SYDNEY WESTERN CITY PLANNING PANEL (Sydney West)

Panel Reference	2017SSW043
DA Number	DA-491/2017
LGA	Liverpool City Council
Proposed Development	Demolition of existing buildings, consolidation of lots and construction of a 5-storey residential flat building comprising 4 x 3 bedroom units, 18 x 2 bedroom units and 4 x 1 bedroom units, above basement carpark. The development is lodged pursuant to the State Environmental Planning Policy (Affordable Rental Housing) 2009.
Street Address	207, 209 & 211 Hoxton Park Road, Cartwright
Applicant/Owner	Applicant – Mr G Adouni Owner – M Raad Holdings Pty Ltd & Adouni Holdings Pty Ltd
Date of DA lodgement	27 June 2017
Number of Submissions	Nil
Recommendation	Approval, subject to conditions of consent
Regional Development Criteria (Schedule 4A of the EP&A Act)	The proposal is for an affordable housing development that has a capital investment value of over \$5 million, the Joint Regional Planning Panel is therefore the determining authority.

Report prepared by	Boris Santana
Report date	15 June 2018

Figure 5 – Extract of the section plan showing the building elements which exceed the height limit.

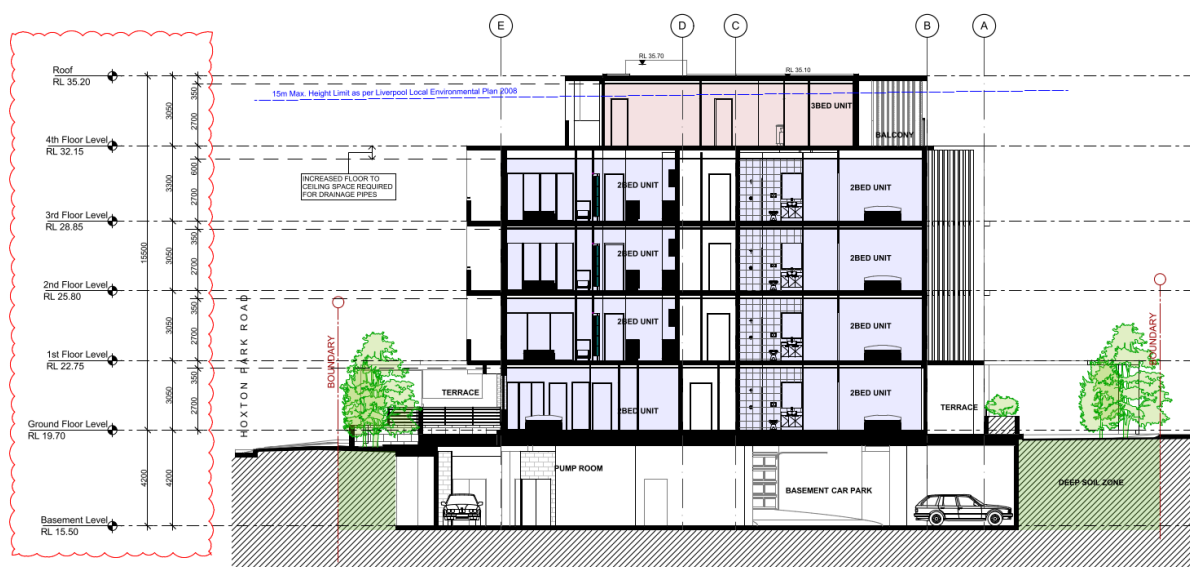
Clause 4.3(2) of the LLEP 2008 identifies a maximum height of 15m for the site.

The development proposes a maximum height of 15.98m to roof slab which represents a numerical variation of 980mm or 6.5% and a maximum height of 16.78m to lift overrun which represents a numerical variation of 1.78m or 11.8%. As demonstrated below, the non-compliant height relates to a portion of level 4 of the development and lift overruns.

In response to the applicant's submission, Council accepts that strict compliance with the applicable height control is unreasonable and unnecessary having regard to the following:

- The height of the ground floor level of the development above the natural ground level ranges from 300mm to 530mm as per the topography of the site which slopes from north to south. The height of the ground floor level, which has been elevated as a result of the drainage design of the development, contributes to the proposed breach in the height limit. The submitted stormwater concept plan indicates that stormwater runoff from the proposed development will be captured at the rear of the site and discharged via gravity to the kerb inlet pit on Hoxton Park Road. Considering this, a reduction to the ground floor level of the building so as to negate any breach in the maximum height limit, will require the applicant to adopt a charged line system. Council's Engineering Branch has advised that a charged drainage system is not ideal as blockage of the system can result in water travelling away from the discharge point, and the system has higher maintenance requirements. In the circumstances, it is considered that the height of the ground floor level is suitable for the purpose of achieving adequate stormwater drainage for the proposed development.
